COMMUNICATIONS - AIRCELL ATG ANTENNA ELECTRICAL BONDING IMPROVEMENT

750 (Citation X+)

SB750-23-19  
Page 1 of 6

Figure 1. Aircell ATG Antenna Electrical Bonding Improvement (Sheet 1)

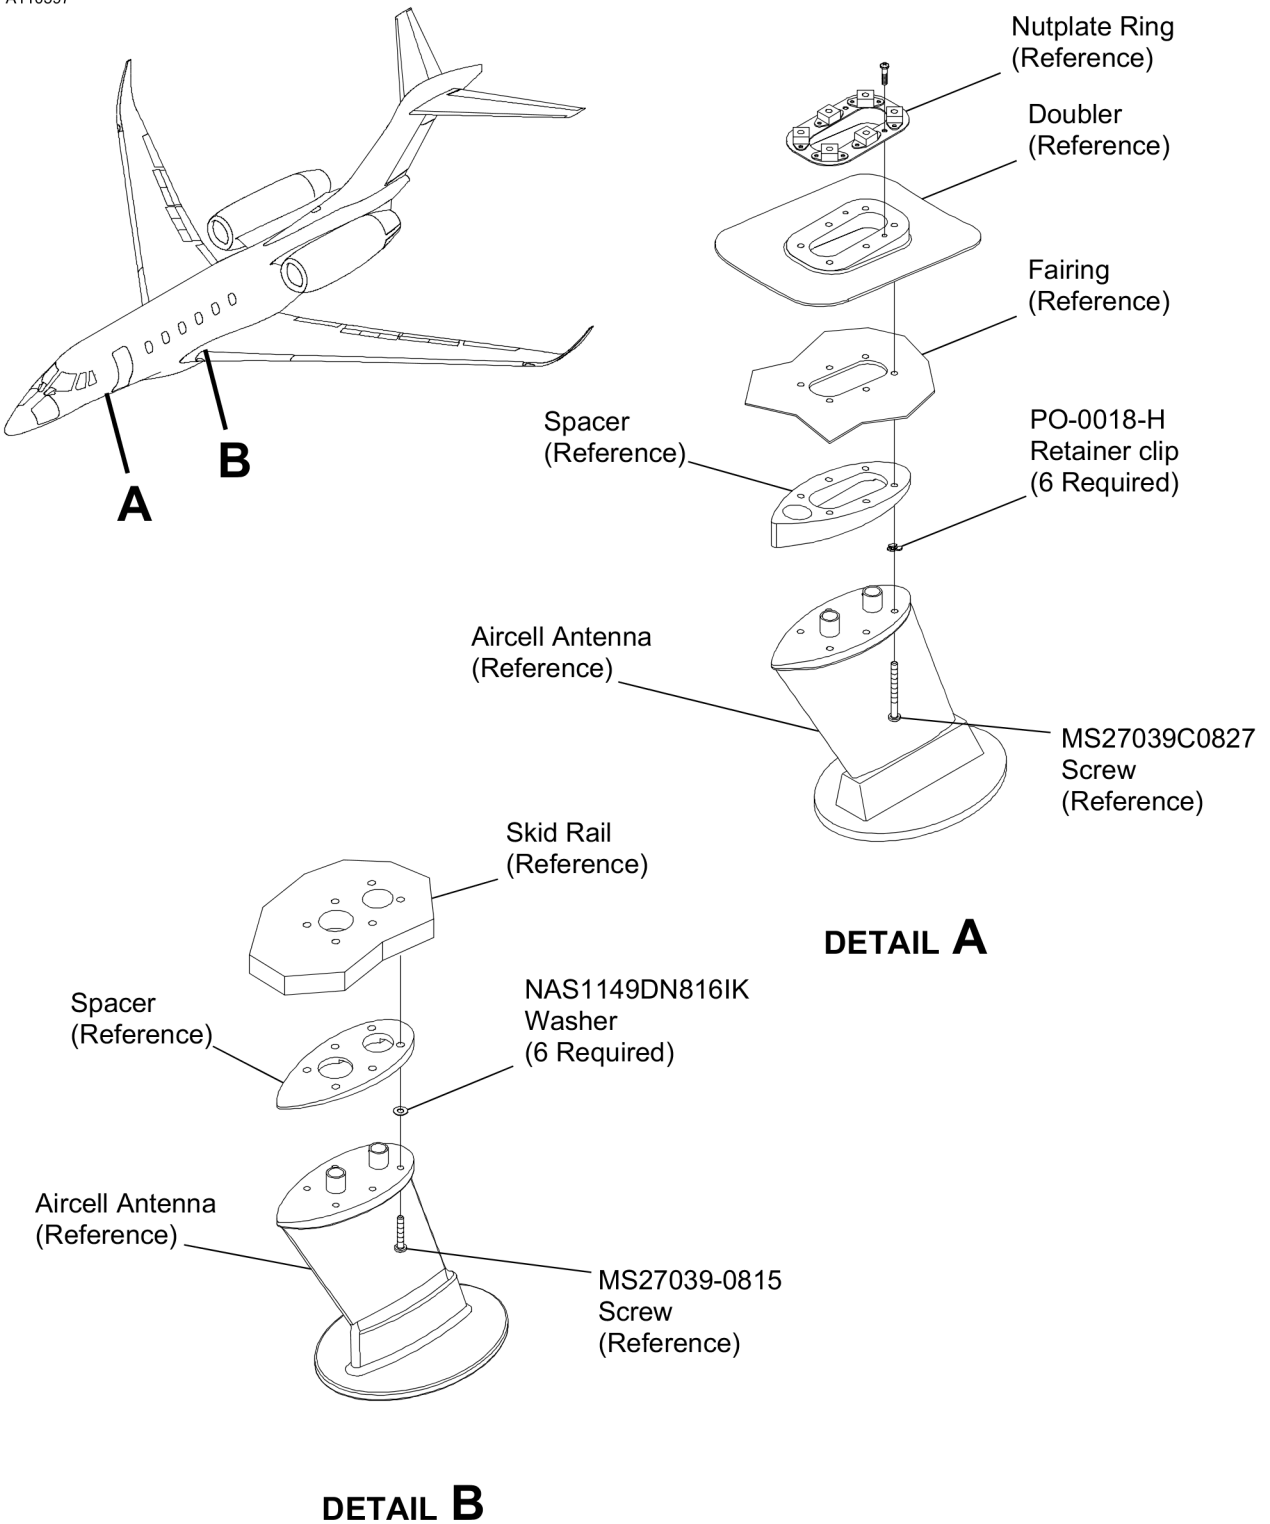
The electrical bonding of the Aircell ATG Antennas can fluctuate which may cause connectivity issues.

This service bulletin contains parts and instructions to add bonding clips and washers to the Aircell ATG Antenna installations.

5. (Refer to Figure 1, Detail A.) Install the forward Aircell ATG Antenna as follows:
  - A. Prepare the 154AB access panel for electrical bonding as follows:

- (8) Install six MS27039C0827 Screws in the antenna.
- (9) (Refer to Figure 1, Detail A.) Install one PO-0018-H Retainer Clip on each screw.
- (10) Apply a fay seal to the upper and lower surfaces of the spacer using U470638 Sealant. (Refer to Citation Standard Practices Manual, Chapter 20, Fuel, Weather, Pressure, and High-Temperature Sealing - Maintenance Practices.)

**NOTE:** Make sure the fay seal is thick enough to fully cover the PO-0018-H Retainer Clips without any voids in the sealant.

6. (Refer to Figure 1, Detail B.) Install the aft Aircell ATG Antenna as follows:

- (4) Install six MS27039-0815 Screws in the antenna.
- (5) (Refer to Figure 1, Detail B.) Install one NAS1149DN816K Washer on each screw.
- (6) Apply a fay seal to the mating surface of the spacer using U470638 Sealant. Except for around the 0.50 inch (12.7mm) diameter electrical bond of each mounting hole. (Refer to Citation Standard Practices Manual, Chapter 20, Fuel, Weather, Pressure, and High-Temperature Sealing - Maintenance Practices.)
